### FEDERAL ENERGY REGULATORY COMMISSION SUSITNA HYDROELECTRIC PROJECT PROJECT NO. 7114

### ALASKA POWER AUTHORITY COMMENTS ON THE FEDERAL ENERGY REGULATORY COMMISSION DRAFT ENVIRONMENTAL IMPACT STATEMENT OF MAY 1984

Volume 2C

Technical Comments

TRR048

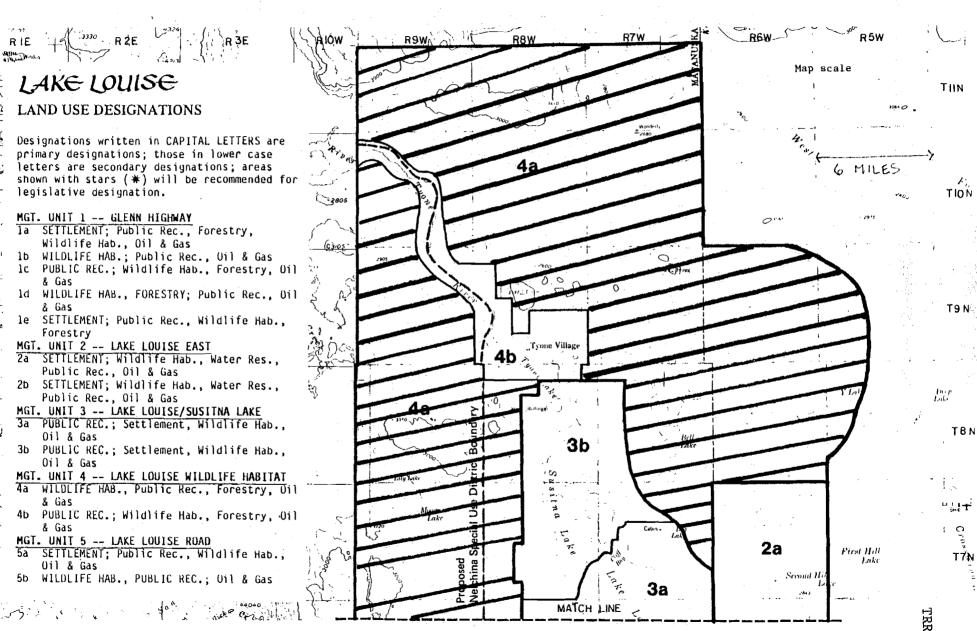
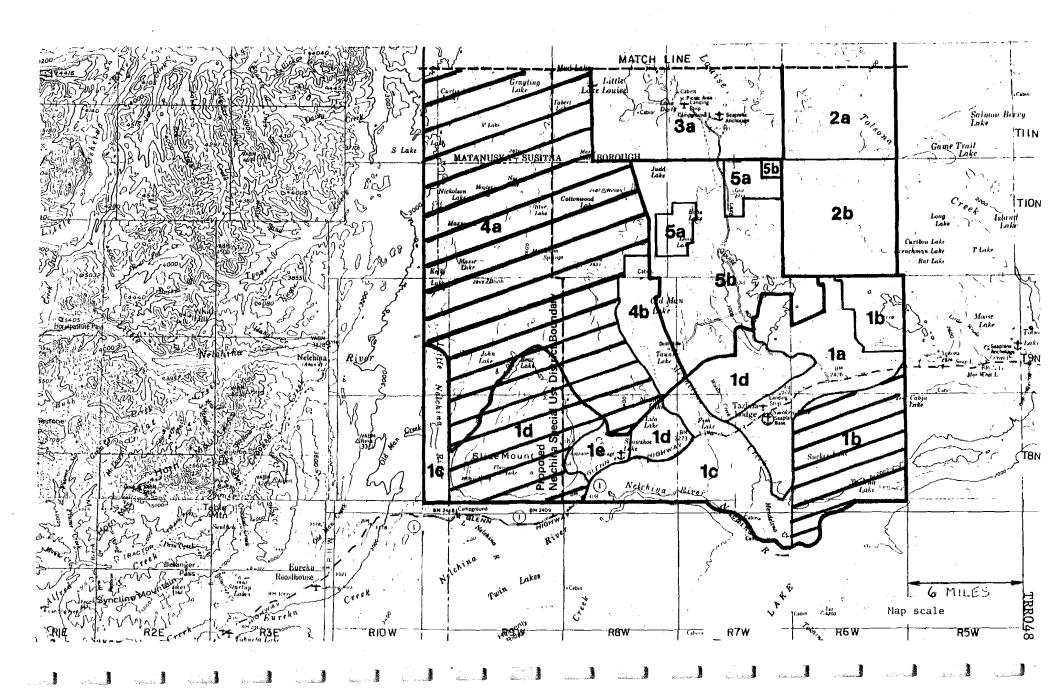
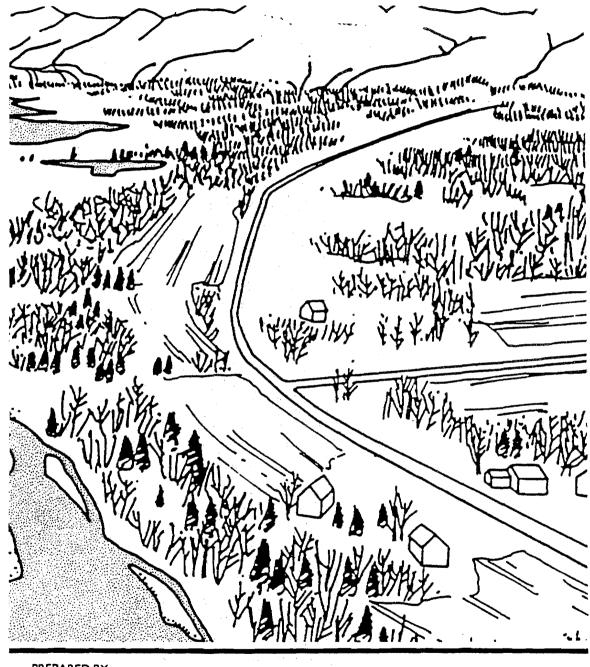
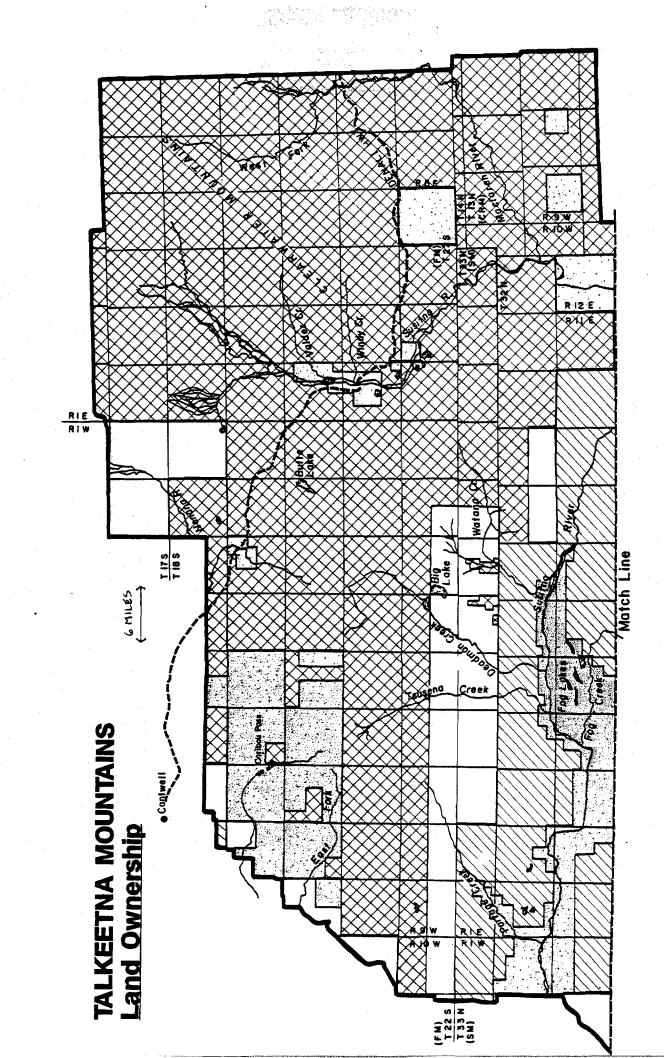
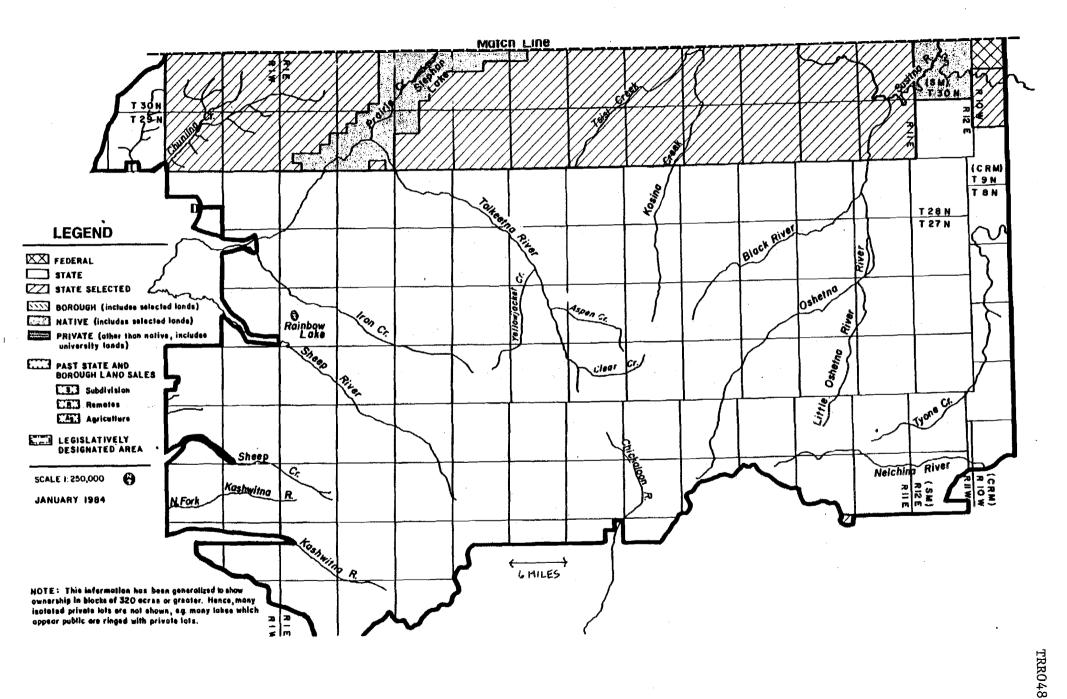
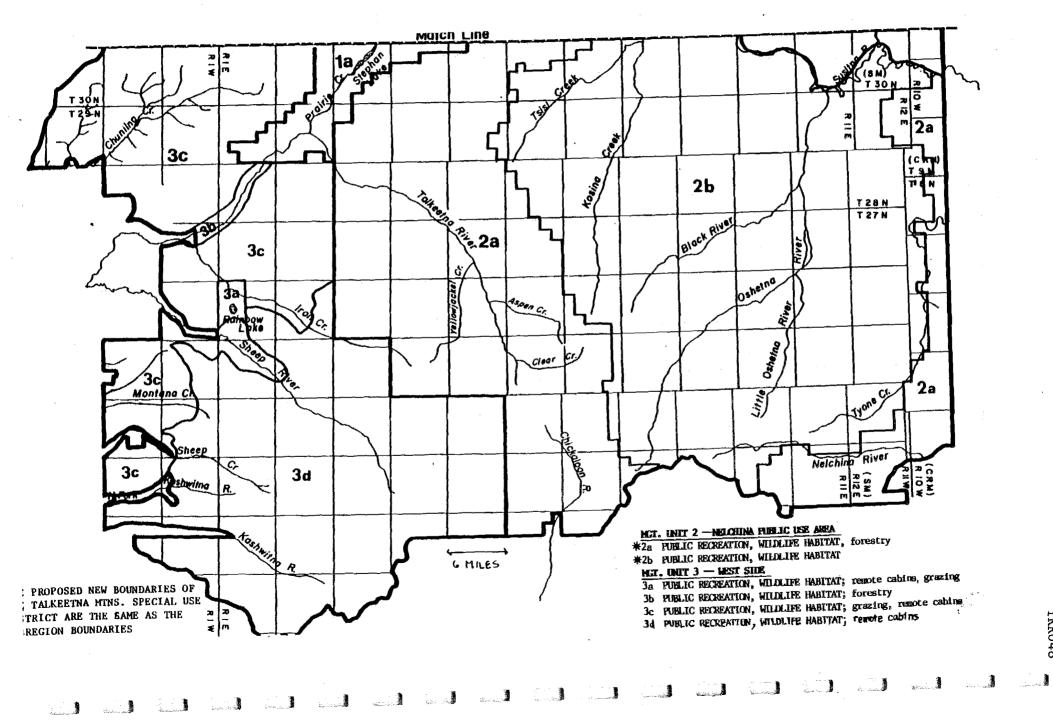
COMMENT IN REFERENCE TO: Candidate mitigation lands for habitat compensation through enhancement.
